MAS SUMANTRA 2 PRIVATE LIMITED

SFB 08, Factory Bay Area, CEPZ, CHATTOGRAM 4223

22 January 2025

DETAILED ENGINEERING ASSESSMENT REPORT FOR SIX STOREY MAIN BUILDING of MAS SUMANTRA PRIVATE LIMITED.

Observation-02: Inconsistencies in design report (Main Building).

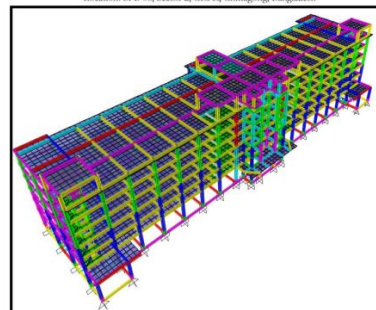
Description: Response modification co-efficient factor, $R=8$ has been considered but required justification/calculation has not been provided in the design report. The building engineer is required to revise the design report as per existing condition and incorporate all kinds of serviceability checks in the design report.

Observation-05: Dampness in the stair slab and walls (Main Building).

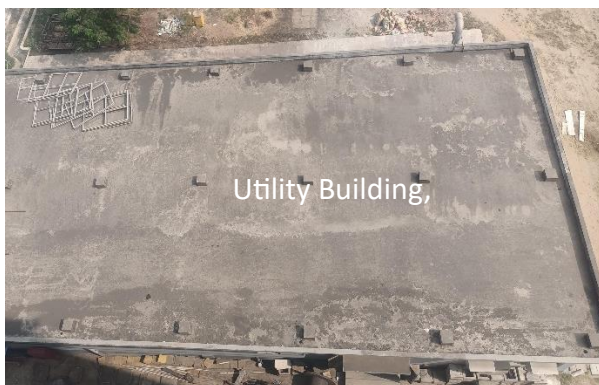
Description: Dampness was found in the stair slab and walls. The building Engineer is required to investigate the damped portion and repair accordingly

Observation-08: Improper drainage on roof (Utility Building, Dry Kitchen).

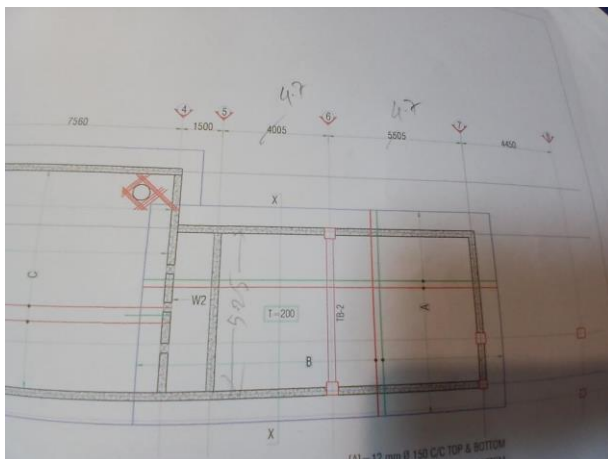
Description: Sign of water clogging was observed on the roof of Utility Building, Dry Kitchen. Building engineer is required to improve the roof drainage with proper slope and adequate number of water outlets.
